TRANSMITTAL OF SIXTH TAAG REPORT - Hmb-13-84

SIXTH REPORT
OF THE
Technical Advisory and Assistance Group (TAAG)

April 1, 1983 to August 1, 1983

FIGURE 1 Time Bandwidth Characteristics of a
Parametric Array

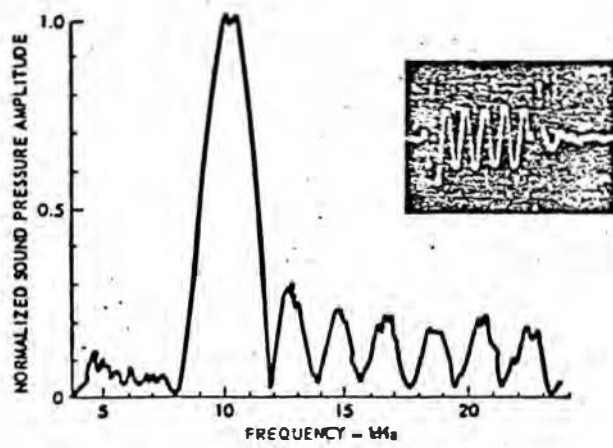
The parametric array utilizes the nonlinear nature of the working fluid (water) to generate two modulation or sideband frequency components from the sum and difference of two primary source frequencies. See figure 1 for an example of reported performance. The parametric array has two characteristics which are very useful. When utilizing the difference frequency sideband, the size of the parametric transducer compared to conventional transducers is greatly reduced. Also, the parametric transducer can be designed to be exceptionally directional. These characteristics allow development in a confined area and assist in reducing signal returns from unwanted directions.

If, as in figure 1, 436 khz is the mean source frequency and 50 cycles are gated, then the time period of pulse, T is:

FIGURE 2a Complicating Factors in Acoustic Imaging Reactor Core Material

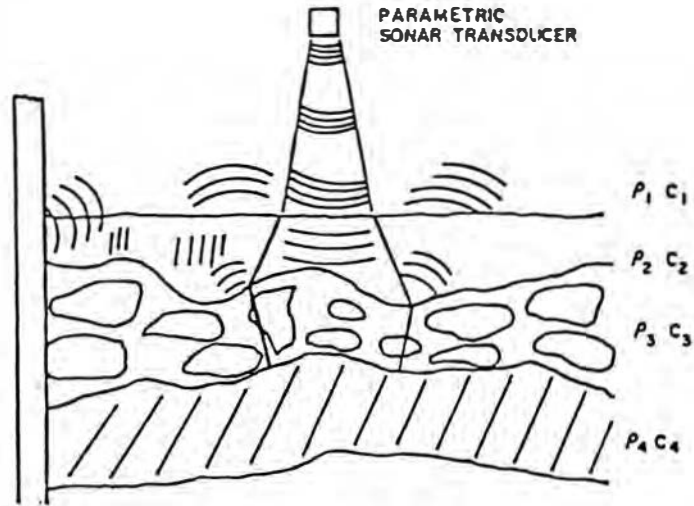
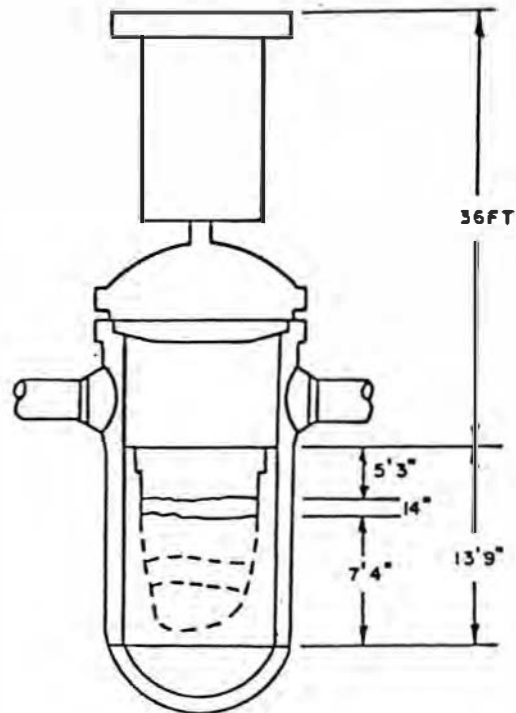
The reactor core material resides in a regular cylindrical shell. This shell will potentially reflect much of the vibrational energy in the core material causing a large number of possible paths (reverberation) for returned vibration energy. See figure 2.

FIGURE 4a Reflection Resolution Equal to One-Half Wave Length. (Compressional Waves Depicted as Magnitude Traces for Concept Presentation Only.)

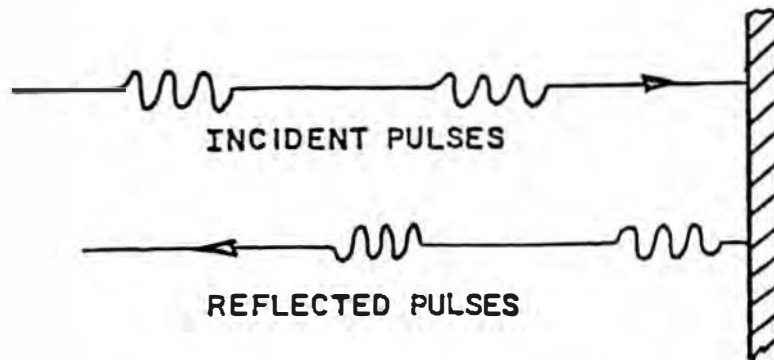
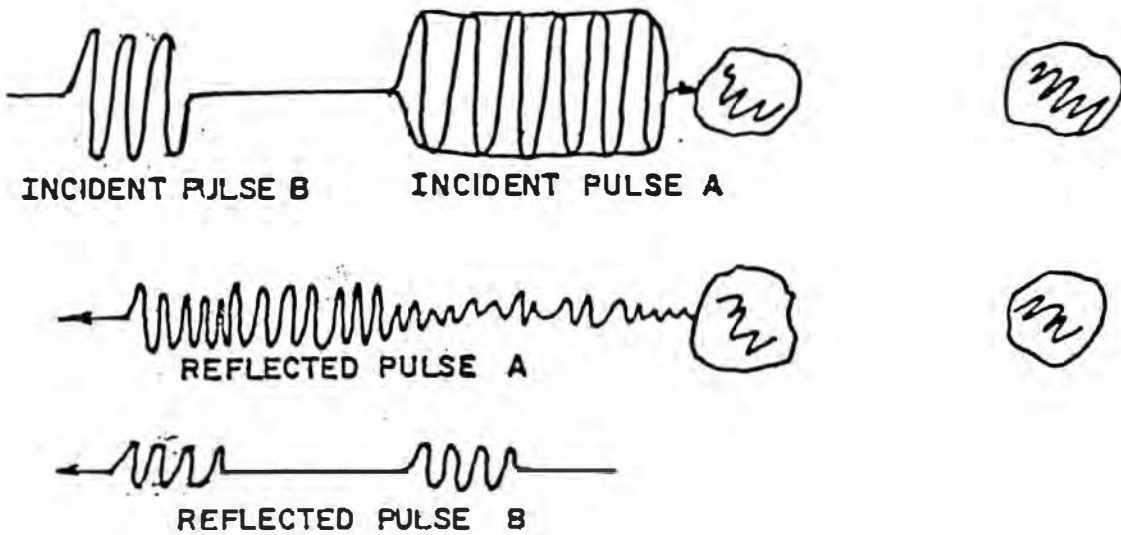
Figure 4 depicts the concepts of single reflection resolution and spacial resolution of a pulsed sinusoidal acoustic signal for multiple objects. Single reflection resolution describes how well the distance to a target can be defined. Generally, because of pulse alteration during reflection and propagation, measurement accuracy is estimated at one-half wavelength. Spacial resolution is depicted in figure 4b for two pulses with different pulse lengths.

FIGURE - 3 DEFUELING ARRANGEMENTS

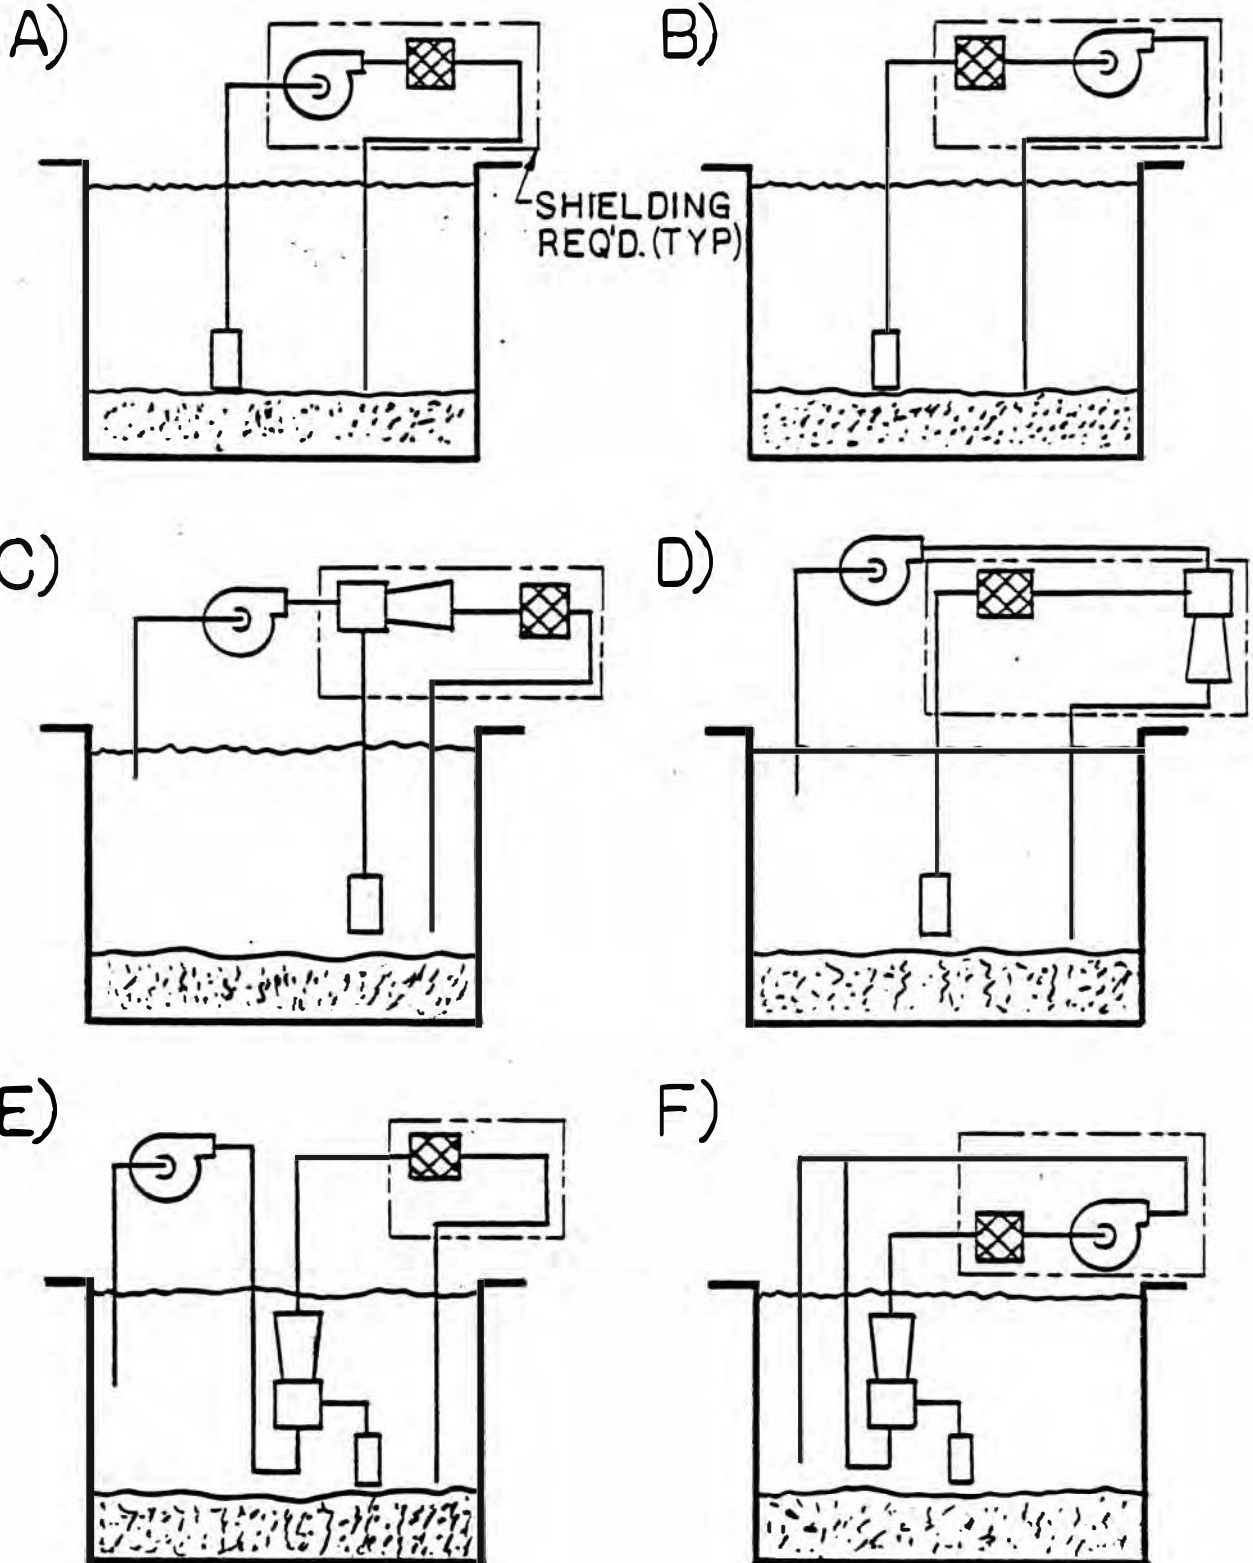
Figure 3 shows six system design concepts for the fuel removal system. These concepts are variations of typical arrangements for hydraulic dredging systems to reflect the special needs of defueling. Concept A is a straightforward system consisting of a suction line, a slurry pump, a solids removing device, and a diffusing return line. The advantages of this system are as follows:

Concept B on Figure 3 is similar to Concept A except that the pump is placed downstream of the debris vessel. This arrangement reduces both the amount of and the size of the solids which pass through the pump. This would permit the use of the less expensive "soft" pumps or would extend the useful life of a "hard" pump. Unfortunately, many "soft" pumps cannot tolerate low suction pressures because the liners separate from the base metal. Hence, a pump with hard wetted parts (BHN >650) would be required. A disadvantage of this concept is the practical limit on the pressure drop through the debris vessel device of about 10 psid. This can be improved somewhat by submerging the pump to take advantage of the pressure of the shield water. However, that solution increases the difficulty of performing any required maintenance that may be required.

Concepts C and D on Figure 3 eliminate all solids requirements for centrifugal pump by removing the pump from the slurry flow stream. This is done by the use of a small eductor to pump the slurry. The maximum flow rate required for this system is approximately 120 gpm which is well within the operating range of small (2" to 4") eductors. The centrifugal pump would take suction from the shield water so it would not need to be a solids-handling pump. Also, since the shield water will not be particularly radioactive, the pump can be located in an easily accessible area to facilitate operation and routine maintenance. The difference between Concept C and D, the location of the debris vessel, is a function of the specific performance characteristics of a given eductor. Clearly, placing the eductor downstream of the debris vessel will increase the service life of the eductor. This results in the same limitation on the debris vessel as does Concept B, i.e., maximum pressure differential of ~ 10 psid. However, placing the eductor upstream of the debris vessel, as in Concept C, raises the potential for blockage due to the restriction of the diffuser portion of the eductor as well as reintroduces the problems of abrasive slurry handling and shortened operating life. It also will reduce the effectiveness of a settling cannister by increasing the flow rate through the vessel.

Concept F on Figure 3 places the pump downstream of the solids eductor. Such an arrangement would be able to deliver the discharge head from the pump to secondary debris vessels downstream of the primary debris vessel. Such a setup has advantages if numerous debris vessels are to be used in series. The use of the solids eductor near the rubble bed provides enough pressure to the suction of the pump to permit the use of a primary debris vessel with a pressure drop greater than 10 psid. The centrifugal pump could probably be a "soft" type pump due to this supplied pressure, thus reducing the cost of the pump. Unfortunately, the pump would be in the debris flow path and will need to be shielded.

A disadvantage of Concepts C, D, and E on Figure 3 is that they all set up an undesirable circulation path within the reactor vessel. Depending on the suction lift, the amount of water needed to drive the eductor can be nearly twice the suction flow rate. This will result in a net flow upward from the rubble bed which could carry fuel fines into the shield water. This effect will be the most prominent with Concept D due to the large suction lift requirements imposed by the solids removal device. Concept E will minimize this effect because both a smaller hose and a lower fluid velocity are possible because of the smaller sized fuel debris.

Figure 10 - GPUN Cleanup System

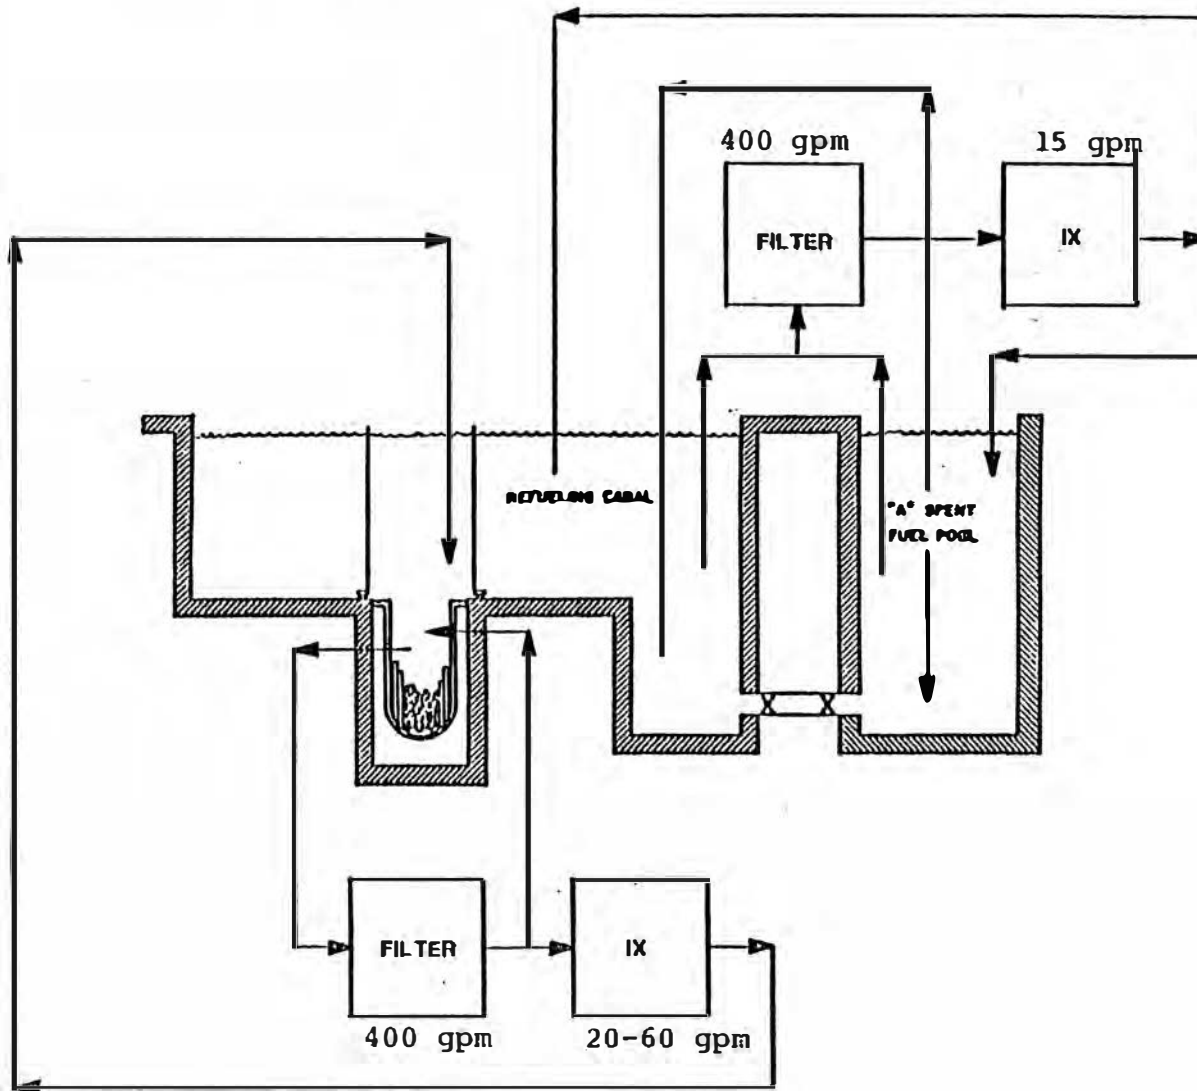
GPU site personnel have developed a defueling water cleanup system which has many of the same features of the system proposed in this Technical Memorandum (Ref. 7). A schematic of that system is shown on Figure 10. This design is the result of a different approach to the problem from the one taken by this Technical Memorandum. Whereas this Technical Memorandum began with existing systems and devised a strategy based on their performance, GPU Nuclear began with the maximum volumes of water that might need to be processed and designed systems based on postulated events during defueling.

However, even this amount of water is inappropriately large because it is unlikely that good water clarity will result because of the unwieldy flow path. Unless a suction nozzle is lowered to the vicinity of the rubble bed, there will be little cleanup of the area near the defueling activities. Since 400 gpm is four times the flow required to remove the fuel debris, care must be taken to prevent gross fuel removal. In order to prevent the water cleanup system from acting as a defueling system, the water velocity must be less than $\sqrt{.1}$ fps, or the suction nozzle must be some distance removed from the rubble bed. At 400 gpm, a 40" ID nozzle is required to keep the fluid velocity below .1 fps. Alternatively, a manifold of nozzles could be used but would be an unwieldy device. This means that the suction nozzle for the R.V. cleanup system must be removed from the area of the rubble bed in order to prevent gross defueling. Hence, the cleanup of the water immediately above the rubble bed will not be accomplished by the R.V. cleanup system even at 400 gpm.

Also, the flow path will do little to remove floating debris from the top of the shield water. It is credible that there could be finely divided particles which will float or remain suspended in the water near the top of the defueling barrier. It is unlikely that returning filtered water to the top of the barrier will successfully remove this floating debris.

The proposed filter design for the R.V. cleanup system is a porous metal tube bundle with a drop-out canister. The flow is through the tubes, inside to outside, with any large debris passing straight through to the drop-out canister (see Figure 11). Such a design must of necessity utilize very large tube surface areas. The velocity of approach must be low to permit the majority of the solids to carry through the tubes to the canister below. For the smaller debris, the major phenomenon is filtration; hence, to avoid the need for frequent backwashing, large tubes are required. Sizing the filtration elements will be a major design effort requiring mockup testing. In addition, the system will not back flush effectively. Since the drop-out canister has no flow, the back washed solids will be flushed back into the reactor vessel. With the maximum canister diameter being held to 12", the 400 gpm flow rate seems too large to accommodate this design and will necessitate a multi-unit filter train manifolded together. While not unworkable, such a system will be cumbersome and expensive, and will require a long lead time for design and procurement.

The size of the GPU Nuclear system is compatible with use of auxiliary building systems if the hot leg suction path is used. However, GPU Nuclear does not plan to utilize this approach. Instead, large portions of the R.V. cleanup system are to be built and installed in the reactor building. The man-REM cost of such an approach is certain to be high. There are very few reactor building penetrations available for use by this system so that it will either be built entirely inside containment or that costly piping system designs will be necessary.
